FERGUSON TOWNSHIP PLANNING COMMISSION
Regular Meeting Agenda
Monday, December 12, 2022, 6:00 PM

1. MP Machinery and Testing at 2161 Sandy Drive Preliminary Land Development Plan

SUBJECT: MP Machinery and Testing at 2161 Sandy Drive Preliminary Land Development Plan

RE: MP Machinery and Testing Preliminary Land Development Plan

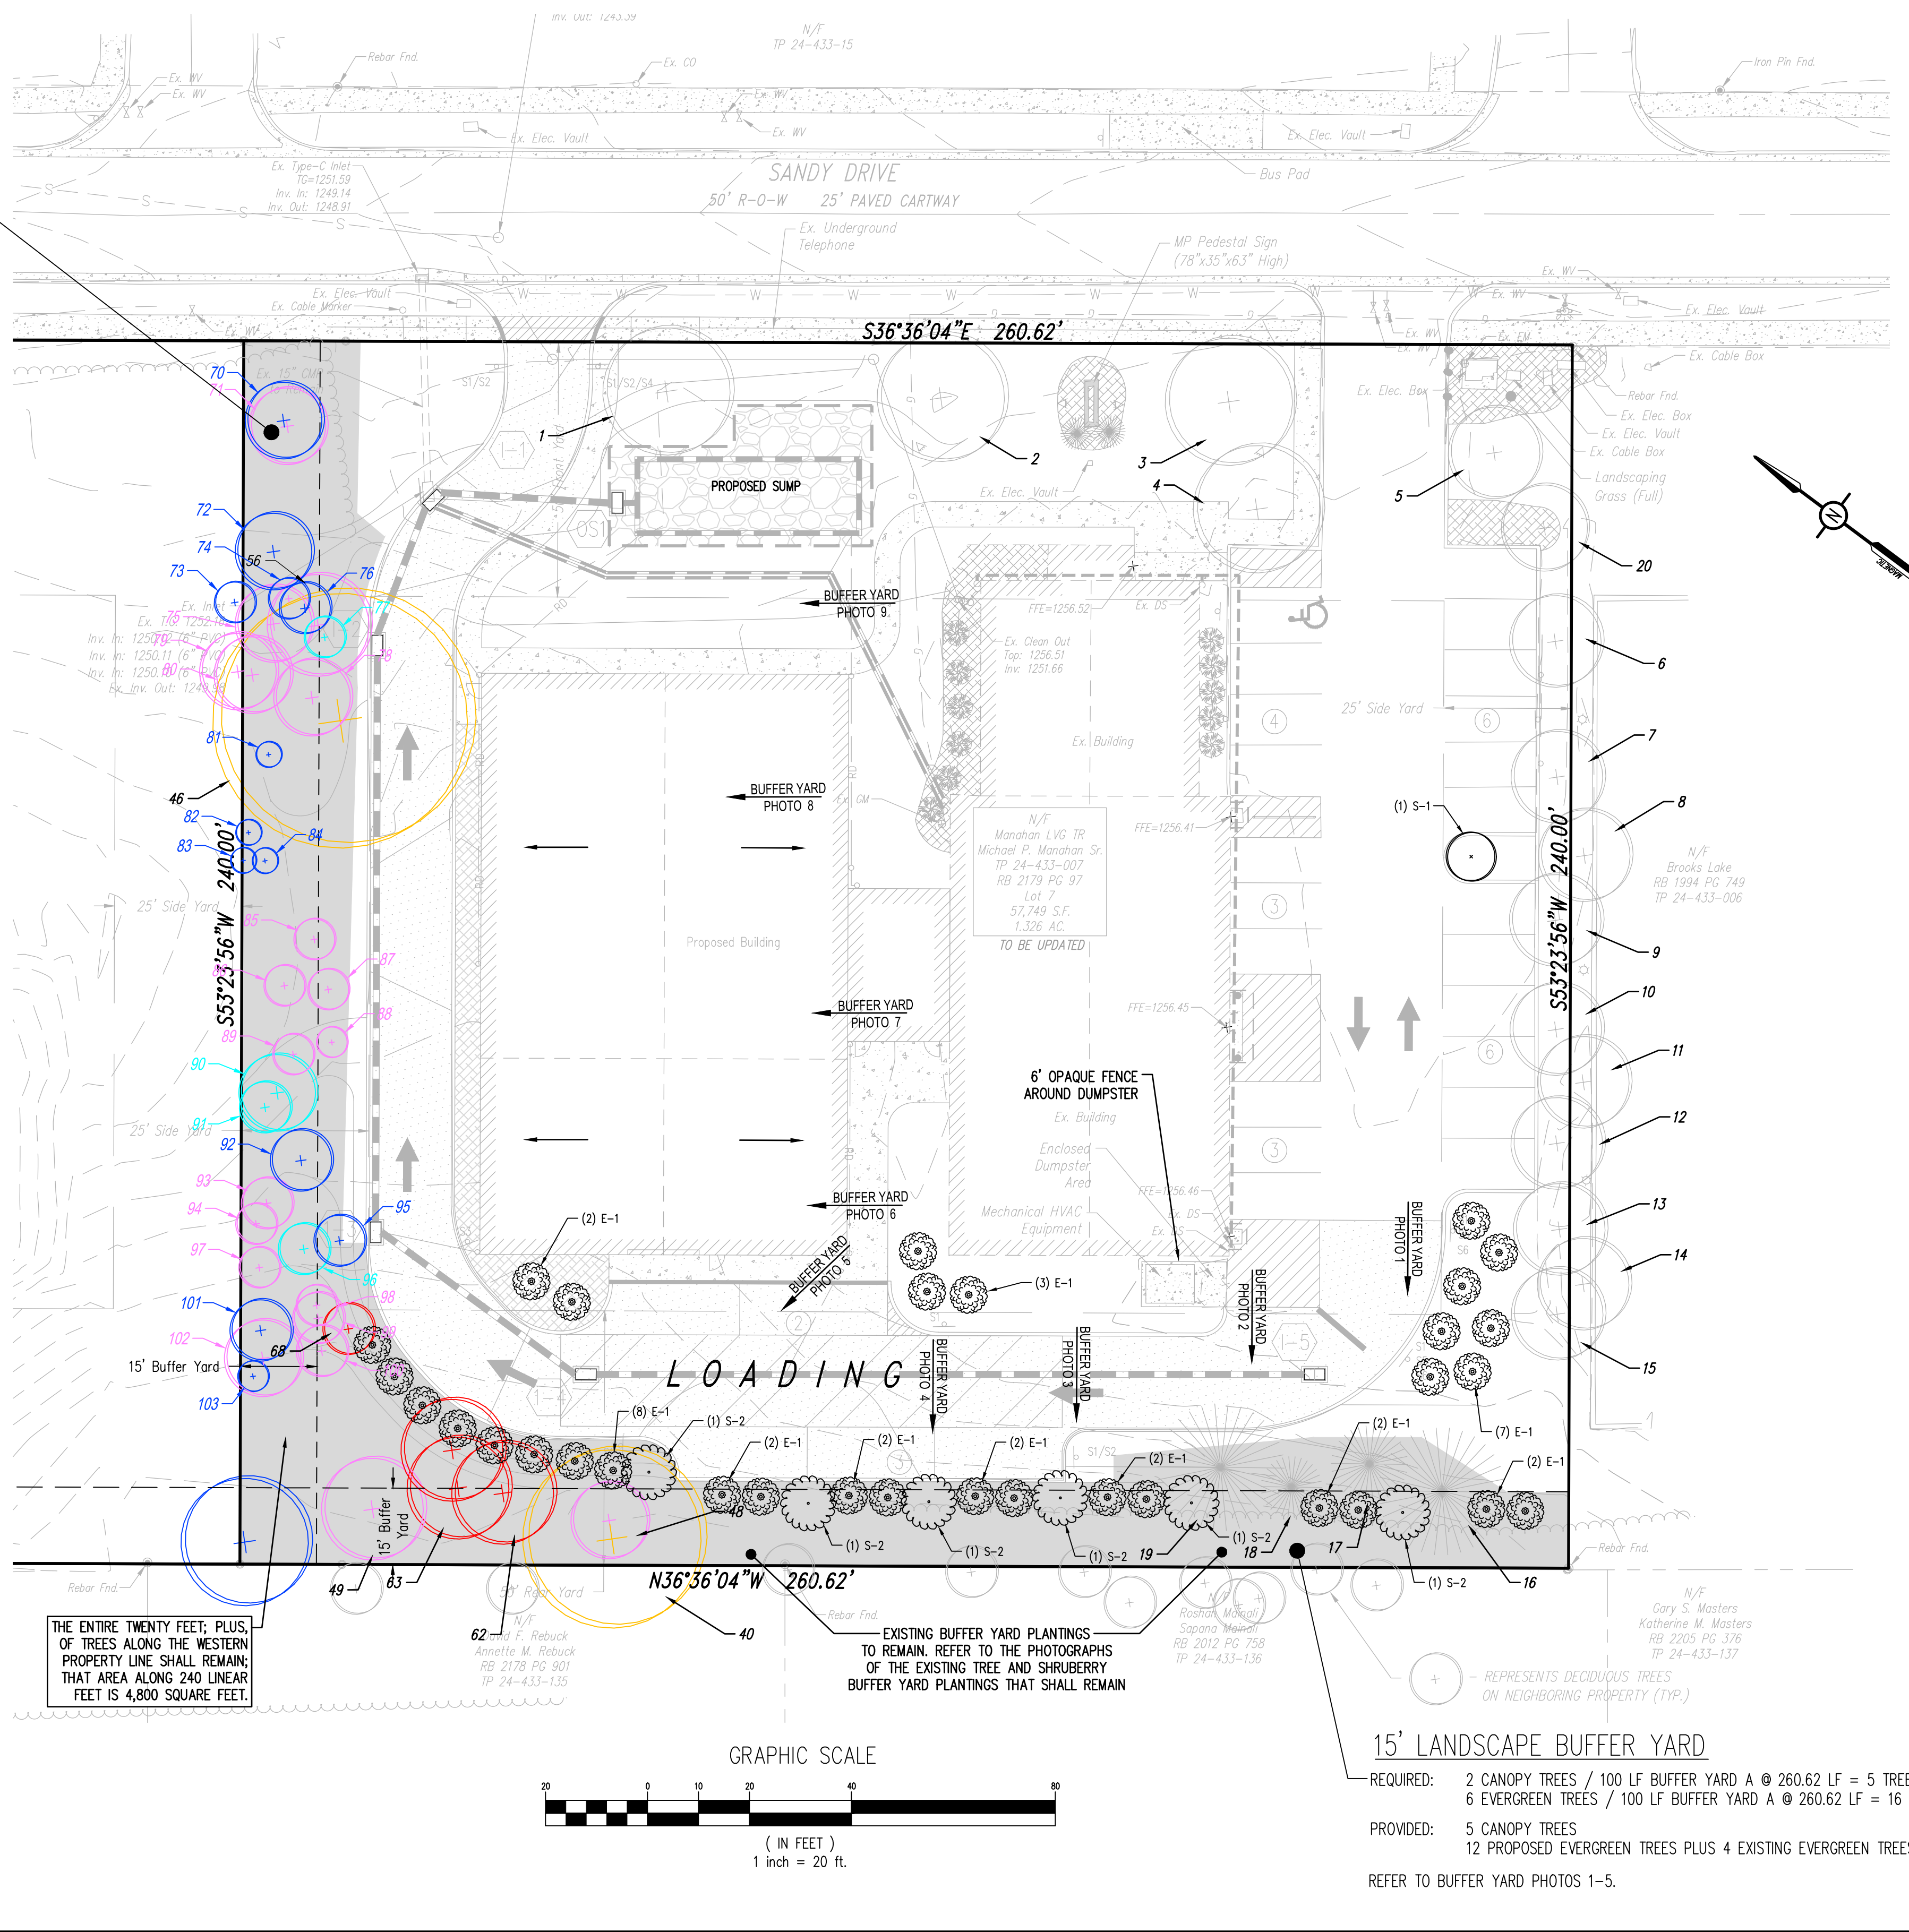
7. The landscaping plan must graphically depict the location of all buffer yards and planting areas. (Chapter 27, Section 401.C.1.g). Comment partially addressed. Provide details of existing plantings
The existing plants are shown on Sheets 6 & 7. We additionally surveyed all trees 1" and greater in size.

8. The landscaping plan must graphically depict the distribution, mature height and spread of all required plant materials. The Official Township plant list shows the plant height and spread which is to be used for each plant species (Chapter 27, Section 707.5.B). Comment partially addressed. Need to have more detail on the existing plantings in the buffer yard.
The existing plants are shown on Sheet 6 & 7. We additionally surveyed all trees 1" and greater in size.

11. The existing landscaping is proposed to be used for the required buffer. The landscaping Ordinance in Chapter 22-516.8 provides the details for approving existing vegetation. Please provide the required plan that details the existing landscaping so that plan can be reviewed for compliance. Comment not addressed. Please provide details of the existing plantings so that the Township can determine if the existing plantings meet the buffer requirements.
The existing plants are shown on Sheet 6 & 7. The trees in the West Buffer Yard are being requested to be considered sufficient to meet and/or exceed the township Buffer Yard Planting Requirements. We have ADDED tree plantings to the existing south/residential side Buffer Yard to guarantee that the Township Buffer Yard requirements are exceeded.

REFER TO BUFFER YARD PHOTOS 6-10 AND THE 'EXISTING TREES TO REMAIN LIST' TO SEE THAT EXISTING TREES MEET AND EXCEED BUFFER YARD REQUIREMENTS
